Our Case Number: ABP-317742-23

Re: BusConnects Bray to City Centre Core Bus Corridor Scheme
Bray to Dublin City Centre.

Re. Planning Application by the National Transport Authority for the construction of the Bray to City Centre Core Bus Corridor Scheme.

Example 1

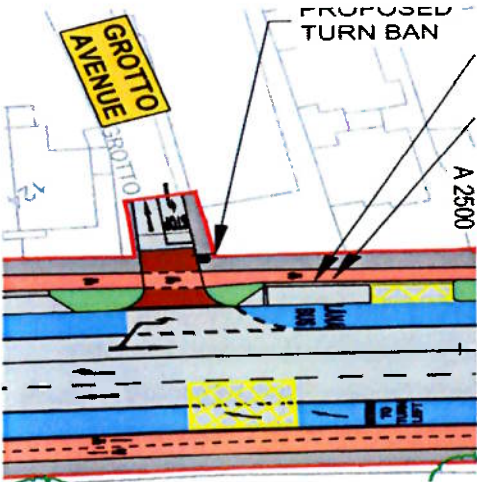
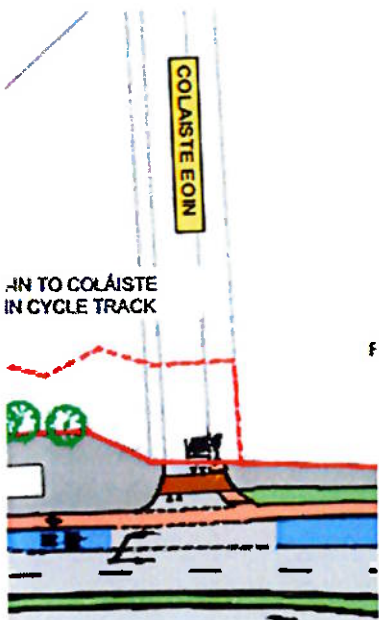
In the interest of pedestrian and cyclist safety, DLRCC has a requirement, where feasible, for the provision of continuous pedestrian and cycle facilities across side roads, similar in design to that proposed under the Blackrock to City Centre CBC scheme at Grotto Avenue (example 1 below). At other side road locations across the Bray to City Centre CBC scheme however, the cycle lane is at grade with the general traffic lane and not accommodated on the raised table (example 2 below).

DLRCC requests that the Board include a condition requiring prior engagement and agreement with DLRCC regarding the final design of the pedestrian and cycle facilities at junctions with side roads in order to ensure an approach which is consistent with the requirements of the Council and the latest version of the Cycle Design Manual.
